**Request for Additional Information No. 373(4393), Supplement 5**

**U.S. EPR Standard Design Certification**

**SRP Section: 07.01 - Instrumentation and Controls - Introduction**

**QUESTIONS for Instrumentation, Controls and Electrical Engineering 1  
(AP1000/EPR Projects) (ICE1)**

**Table 07.01-21-1—EMF-2110NP(A), Figure 3.5, “Software Layers of the Runtime System of One Processing Module”**

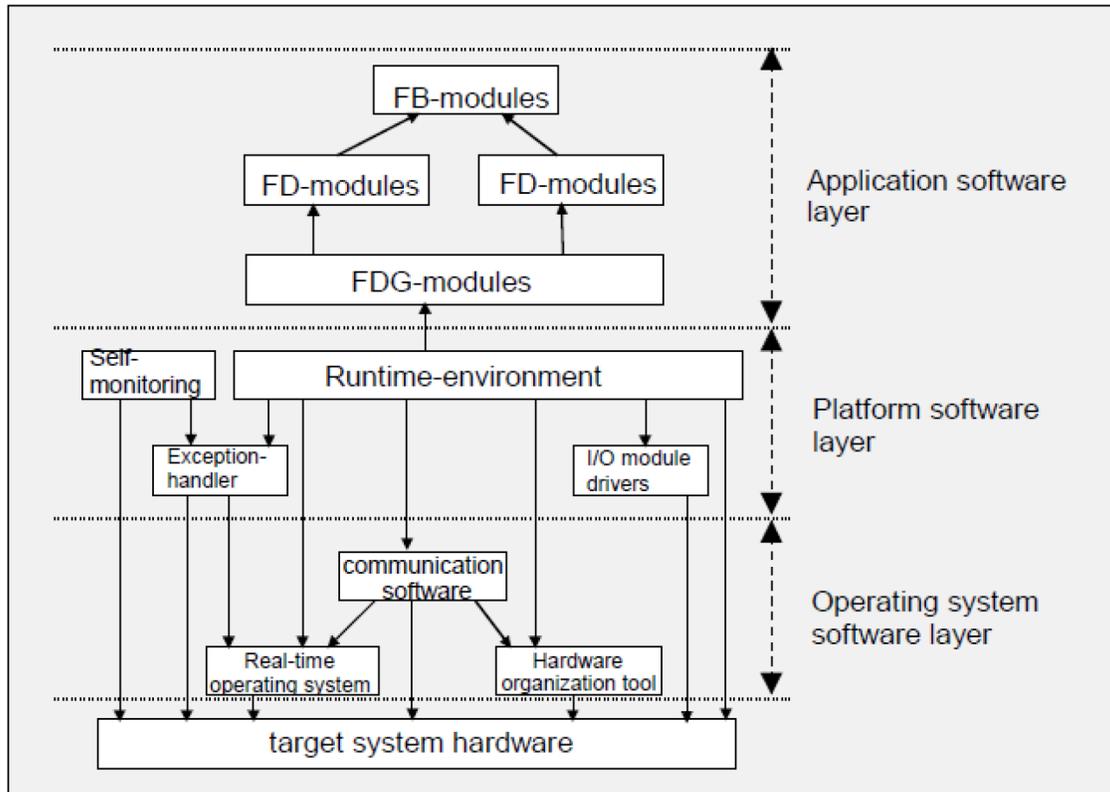
Section 7.1, Definitions, defines system software as referring to “relevant software including an operating system, firmware, and runtime software that is integrated to form a generic I&C platform.” Section 7.1.1.4.3 of the FSAR states that “the logic for the safety related priority module is implemented with firmware-only based devices (e.g. EEPROM) with no system software or application software.” This assertion in Section 7.1.1.4.3 that firmware is not considered software is inconsistent with the definition. Provide clarification of the apparent discrepancy.

The definition of system software in Section 7.1, “Definitions,” was intended to illustrate contrast between layers of TXS software that do not change based on a specific application, and those that are configured uniquely for each specific application. Table 07.01-21-1 is a reproduction of EMF-2110NP(A), Figure 3.5 that provides graphical representation of the different layers of software on a TXS processor. The operating system and platform software layers shown in EMF-2110NP(A), Figure 3.5 are those considered “system software” in the TXS platform. The definition of “system software” in U.S. EPR FSAR Tier 2, Section 7.1 will be revised:

~~System software~~—refers to relevant software including an operating system, firmware, and runtime software that is integrated to form a generic I&C platform. System software – The layers of software that are not configured uniquely for a specific I&C application. System software has a different functional purpose compared to “application software” (defined above) and is the same on all TXS processors. In contrast, application software is configured to reflect a nuclear power plant’s specific

safety system functional requirements, different application software functions reside on individual TXS processors within the overall TXS system. For TELEPERM XS, system software is defined as the operating system and platform software layers shown in Figure 3.5 of Reference 6.
